Part 2 — Technical Requirements

Application under the *Agricultural Operation Practices Act* for a confined feeding operation, manure collection area, and/or manure storage facility(ies)

NRCB USE ONLY	Application number	Legal land description
<input type="checkbox"/> Approval <input type="checkbox"/> Registration <input checked="" type="checkbox"/> Authorization <input type="checkbox"/> Amendment	RA23025	E 1/2 4-45-19 W4M

Dairy CFO permitted under Approval RA17058X. The application is for an expansion to the heifer shed and building a manure storage pad.

A201

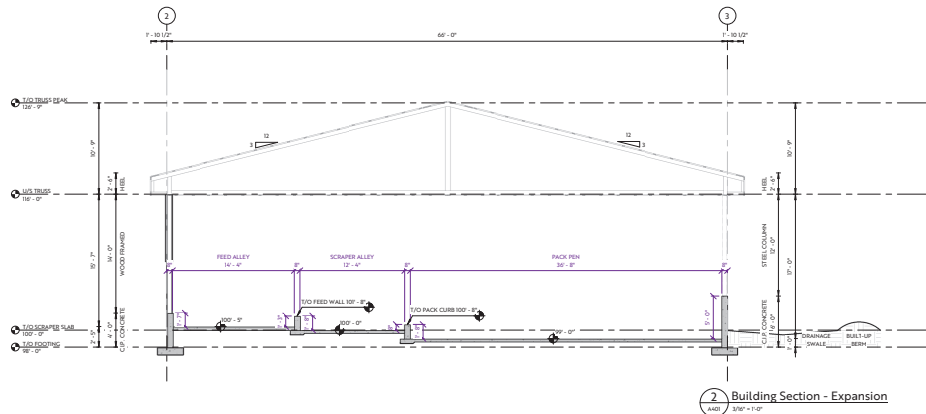
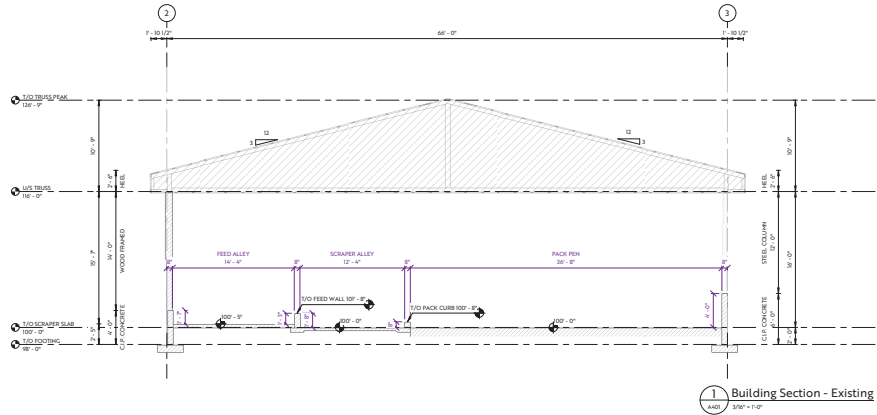
Facility description / name (as indicated on site plan) 1. Scraper alley (expansion to heifer shed)
2. Manure Collection Area (See pageA201) (Solid manure pad)

Requirements met: ☐ YES ☒ NO

A condition will be included in the authorization requiring the permit holder to provide written proof that the constructed concrete liner meets the Technical Guideline Agdex 096-93. The concrete liner for manure storage pad must have a strength of at least 30MPa.
